KWM-2/KWM-2A TRANSCEIVERS
SERVICE BULLETIN NO 8

EQUIPMENT: KWM-2 Transceiver (522-1611-000)
KWM-2A Transceiver (522-1792-000)

SUBJECT: A. Eliminate AGC overshoot on noise pulses and provide dual time-constant action
B. Change source of delay bias to the AGC rectifier
C. Add delayed-decay (hang) AGC to the rf amplifier

Part A, Schematic Change

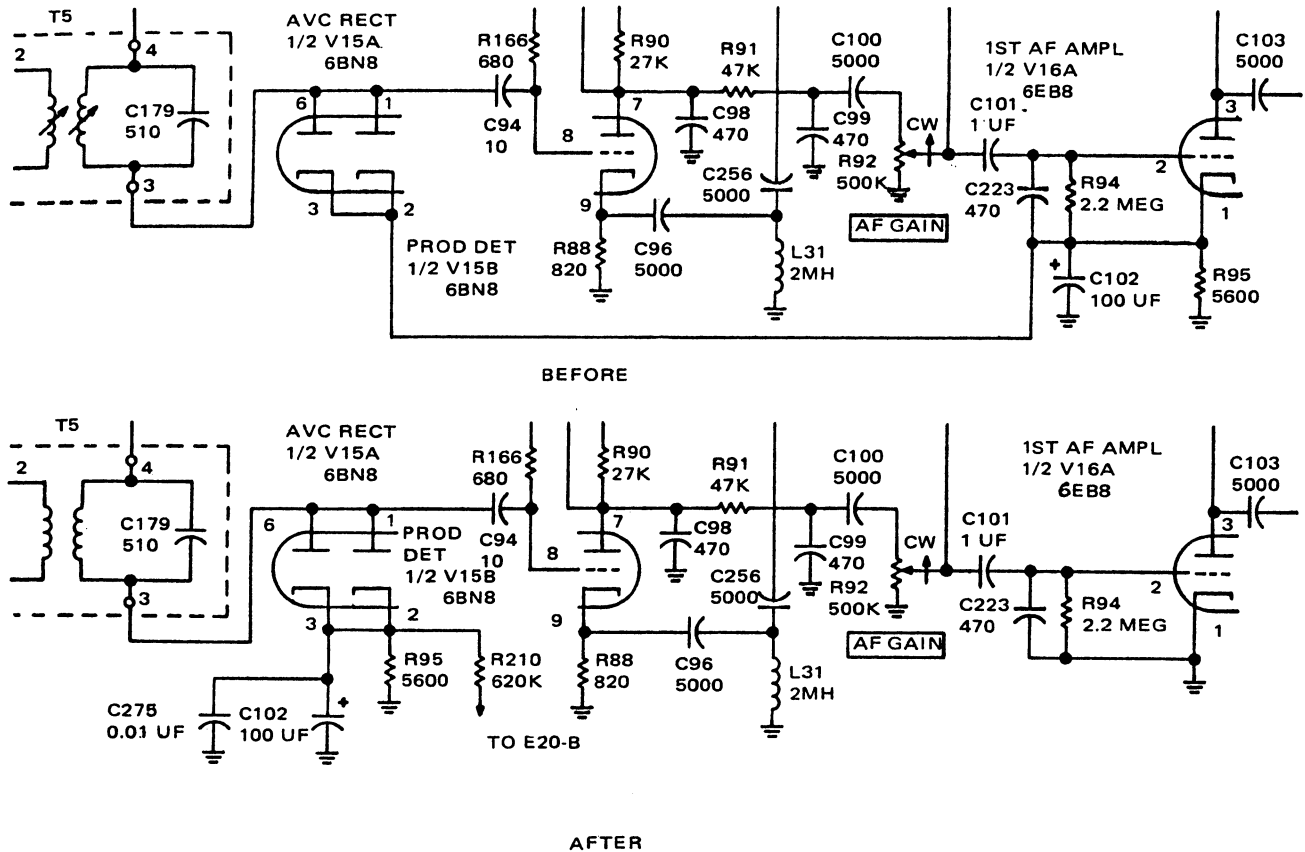
3. Part A: Eliminate AGC overshoot on noise pulses and provide dual time-constant action:

- (a) Place transceiver upside down on workbench with knobs to the right. Remove and save the screws used to attach the two nylon cable buttons to the strengthening rail. Remove and save the screw attaching the rear of the strengthening rail to the chassis. Remove and save the screw attaching the front of the strengthening rail to the chassis, taking care not to lose the nut, lockwasher, and flat washer underneath the rail. Remove the rail, saving any protective material located between the cable and the rail.
- (b) Remove all components attached to E30-C, as follows:
- 1) 4700-ohm 1/4-W resistor, R82, connected from T5 terminal 4 to E30-C.
 - 2) 0.01 μ F disc ceramic capacitor, C92, connected from E30-I to E30-C.
 - 3) 3.3-m Ω 1/4-W resistor, R83, connected from E30-C to E30-J.
 - 4) 0.05- μ F capacitor, C93, connected from E30-C to E30-J.

- 5) 150-k Ω 1/2-W resistor, R180, connected from TS8-1 to E30-C.

- (c) Remove 0.001- μ F disc ceramic capacitor, C256, connected from TS8-1 to ground ring on power connector.
- (d) Connect R83, 1.5-M Ω 1/2-W resistor (745-1485-00), from E30-C to E30-J.
- (e) Connect C93, 0.47- μ F capacitor (913-3804-00) from E30-C to E30-J.

- (f) Connect R82, 4700-ohm 1/2-W resistor (745-1380-00), from T5 terminal 4 to TS8-1. Use sleeving on leads and route this resistor around E30.
- (g) Connect R180, 680-k Ω 1/2-W resistor (745-1471-00), from TS8-1 to E30-C.
- (h) Connect C265, 0.01- μ F disc ceramic capacitor (913-3013-00), from TS8-1 to E30-C.
- (i) Connect C90, 0.01- μ F disc ceramic capacitor (913-3013-00), from TS8-1 to ground ring on power connector.
- (j) If no additional modifications are to be implemented, replace all hardware by reversing step (a).
- (k) Mark SB 8A on information chart (280-3778-010) and apply chart to convenient location on unit, or mark existing chart if one is present.

Part B Schematic Change

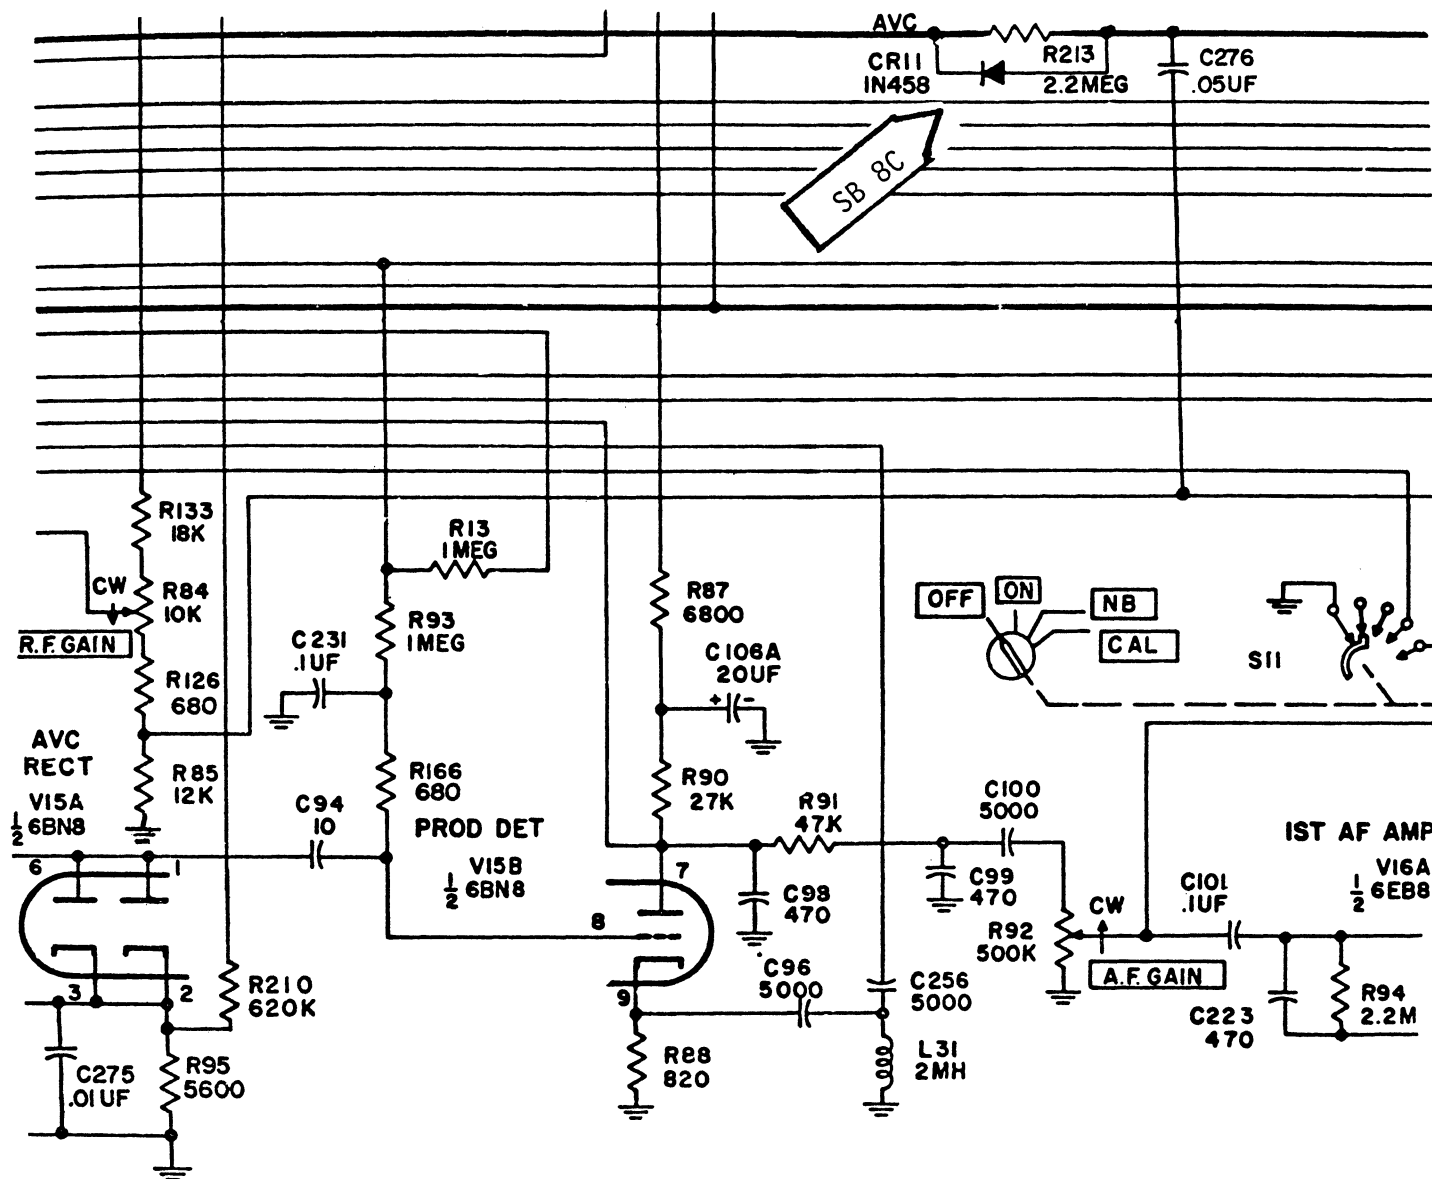
4. Part B: Change source of delay bias to the AGC rectifier:

- Disconnect bus wire at tube socket XV15-2. Remove sleeving and route wire to center shield on XV16. Shorten wire as necessary, connect and solder.
- Add 620 k Ω resistor R210 (745-1469-000) from E20-B to XV15-2.
- Add 0.01 μ F capacitor C275 (913-3013-000) from XV15-3 to nearest ground.
- Mark information chart (280-3778-010) SB 8B. Apply chart to convenient location on unit if one is not present.
